**STATE OF DELAWARE
EXECUTIVE DEPARTMENT
OFFICE OF STATE PLANNING COORDINATION**

August 18, 2015

RE: PLUS review 2015-07-08; Carillion Square

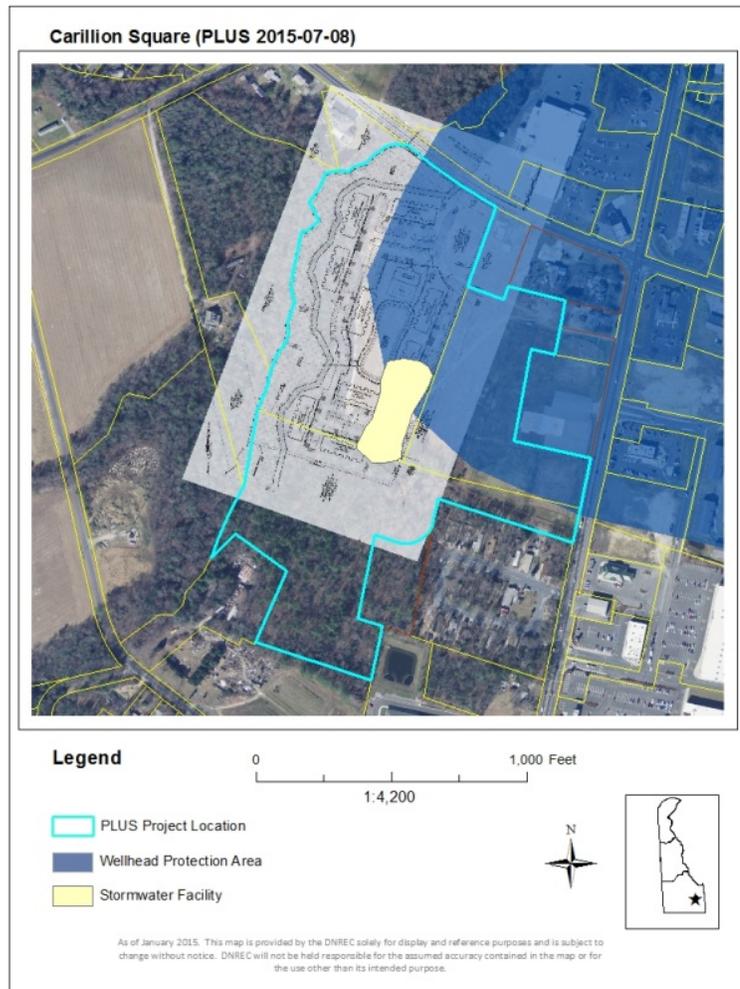
The site plan shows infiltration ponds for the management of stormwater (see map below). While these systems address the particulate and nutrient components of stormwater runoff, they do not address pathogens, petroleum hydrocarbons, pesticides, other organic compounds, and other inorganic compounds associated with residential land use (DNREC, 1999). Because this is wellhead protection area, there exists the potential for these constituents to enter the aquifer and compromise water quality.

GPB recommends, moving the stormwater infiltration pond to an area outside the wellhead protection area.

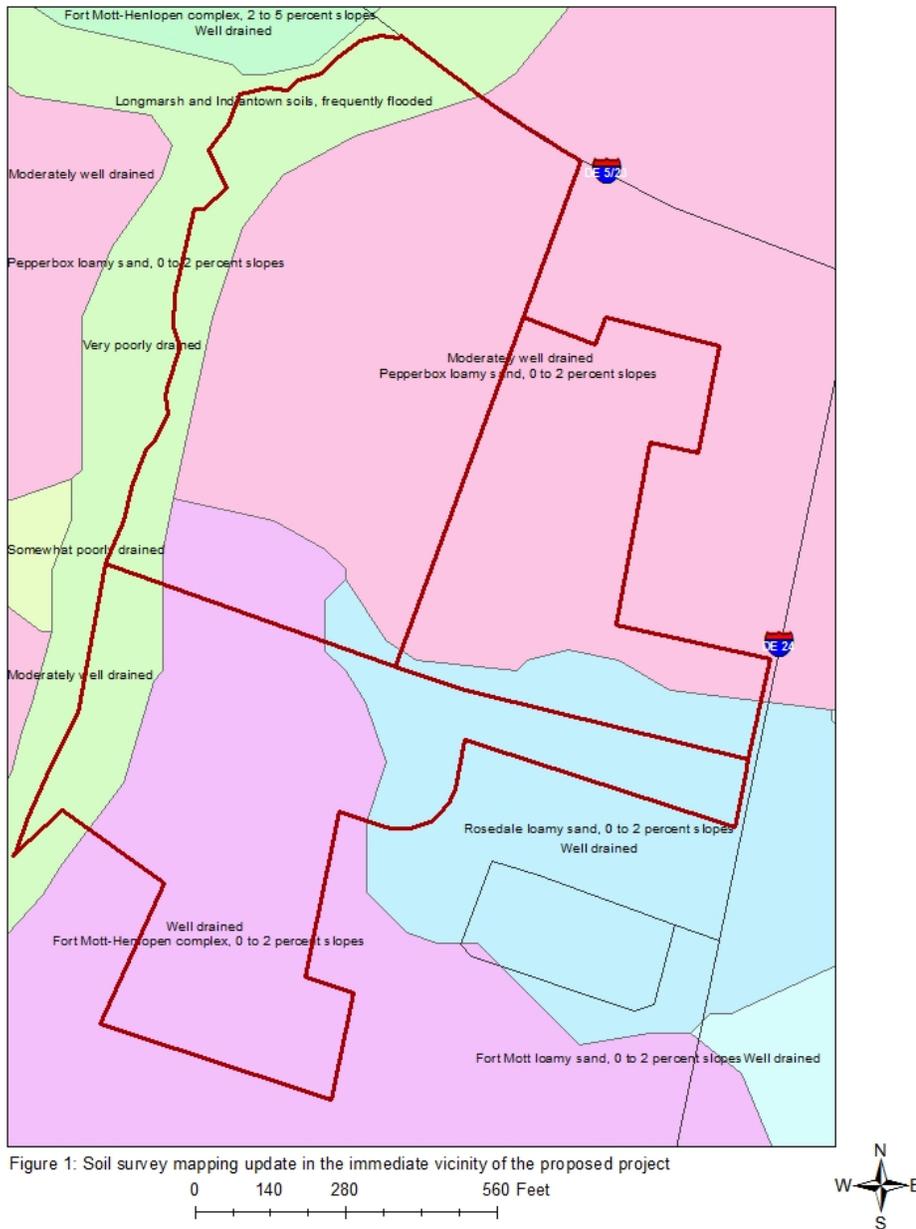
- Based on soils NRCS survey mapping update, the soil mapping unit with the most limitations for development is the Longmarsh and Indiantown soil mapping unit (Figure 1).
